PARKMERCED PROJECT EIR

Comments and Responses

**CITY AND COUNTY OF SAN FRANCISCO
PLANNING DEPARTMENT CASE NO. 2008.0021E**

To: Members of the Planning Commission and Interested Parties
From: Bill Wycko, Environmental Review Officer
Re: Attached Comments and Responses on Draft Environmental Impact Report
Case No. 2008.0021E: Parkmerced Project

SOURCE: Page & Turnbull, Turnstone Consulting
PARKMERCED PROJECT
 EXISTING PROJECT SITE BOUNDARY - - - HISTORIC DISTRICT BOUNDARY
 - - - - - ORIGINAL PARKMERCED PROPERTY BOUNDARY
C&R FIGURE 1: EXISTING AND ORIGINAL PARKMERCED PROPERTY BOUNDARY

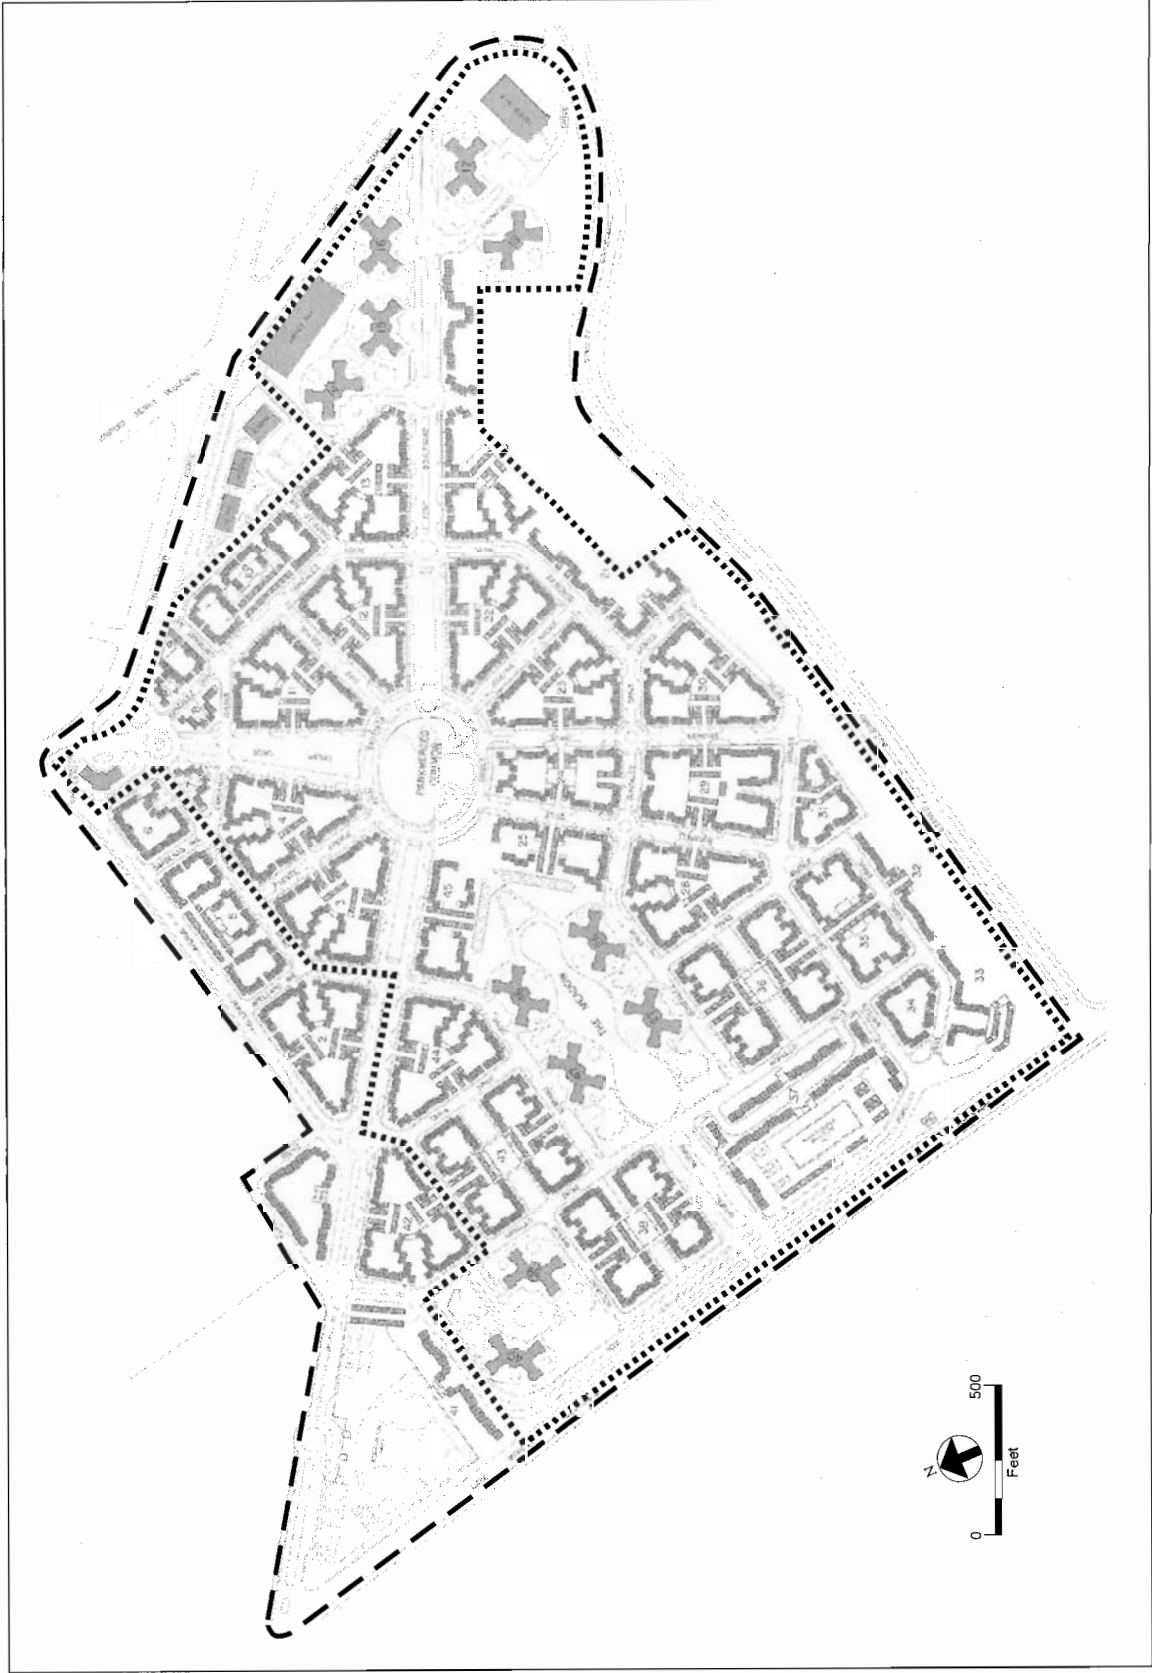
These comments assert that the Draft EIR does not provide sufficient information on the historic resources at the Project Site, as well as on the boundaries of the identified potential historic district. Many comments question the Draft EIR’s conclusions regarding which features contribute to the historic district and the extent of the potential historic district boundaries. The comments request a visual and narrative description of the district boundaries. Some comments question the adequacy of the research for the HRE, which was the basis of the Draft EIR Historic Architectural Resources section. Also, some comments correctly identify that a historic resource, under CEQA, does not distinguish between being eligible for, and being listed in the California Register of Historical Resources. Comments also assert that the evaluation of the Proposed

As indicated by the above quote, the boundaries of the historic district encompass the Parkmerced development as conceived in 1951. (See Figure C&R.1: Existing and Original Parkmerced Property Boundary.) Specifically, the historic district boundaries start at the southwest intersection of 19th Avenue and Holloway Avenue, run west along Holloway Avenue, turn north on and around the south/east side of Tapia Drive, then run northwest along Font Boulevard, turn south on Lake Merced Boulevard, then east on Brotherhood Way, then north on Junipero Serra Boulevard to 19th Avenue. Therefore, the potential Parkmerced Historic District boundaries encompass all parts of the original Parkmerced property, including those portions currently owned by other entities, such as the vacant property at 800 Brotherhood Way and the portions owned by San Francisco State University.

FIGURE V.N.1: LOCAL GEOLOGY MAP

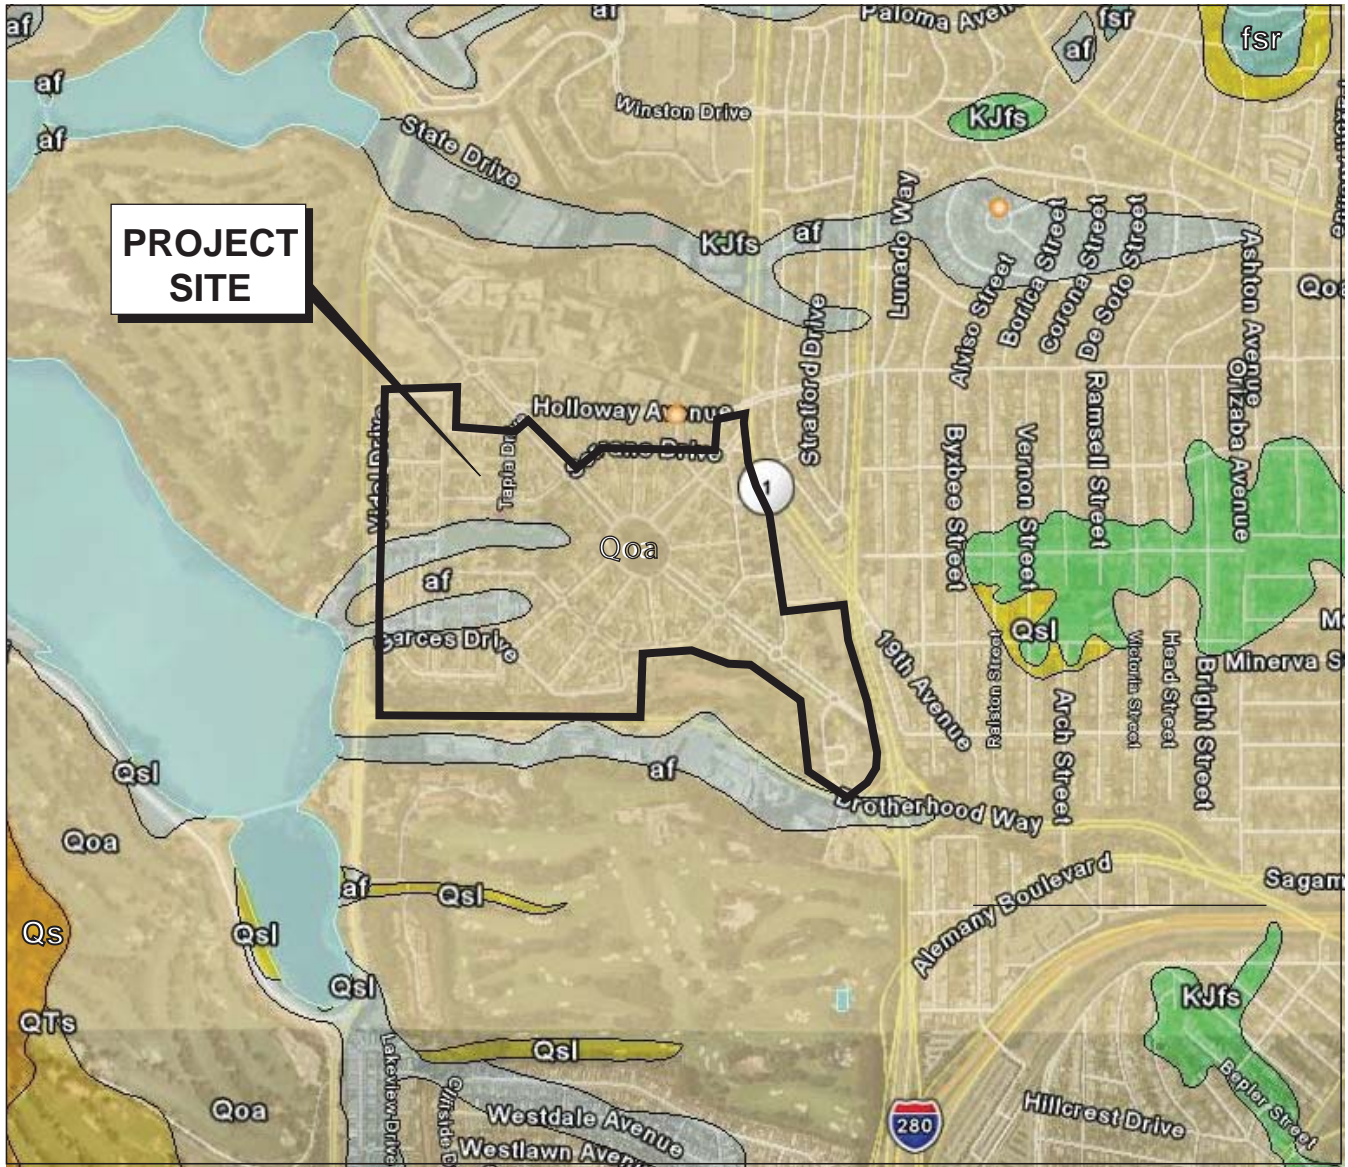
Many comments received on the Parkmerced Draft EIR raise similar issues related to seismic hazards. The following comments discuss seismic hazards and are responded to in whole or in part by this Seismic Hazards Master Response: TR.2.1, TR.18.4, 6.6, 27.1, 33.3, 50.2, 54.A.20, 54.B.8, 54.B.10, 54.B.18, 54.B.41, 54.B.43, 54.B.44. The main points raised in these comments are summarized below:

The EIR assesses the potential seismic hazards for the Proposed Project and concludes that there would be no significant impacts related to seismic hazards (see Impact GE-2, pp. V.N.12-V.N.13). New structures would be designed and constructed in accordance with the most up-to-date codes. As noted on p.V.N.12, during its review of the building permit applications for new buildings on the Project Site, the City's Department of Building Inspection (DBI) would use site-specific geotechnical reports prepared by a California Certified Engineering Geologist or a California Registered Geotechnical Engineer during final design of each new building or building complex. DBI would ensure that all new buildings would comply with the San Francisco Building Code requirements for structural safety in effect at the time that each permit is issued.

As noted on p. V.N.1, a geotechnical report was prepared for the Proposed Project by a California-licensed geotechnical engineer in order to evaluate site conditions and potential hazards, and to develop preliminary recommendations for shoring and construction.² The report determined that the likelihood of specific seismic-induced hazards such as ground rupture or tsunami or seiche was very low or nil.

The report also assessed the potential for seismically induced ground failure due to the strong shaking that would be experienced on the site due to a major earthquake on the nearby faults. Most of the site is underlain by sand, except in limited areas where fill is present. The geotechnical report concludes that subsurface information indicates liquefaction and/or lateral spreading should not be an issue for the majority of the planned improvements.
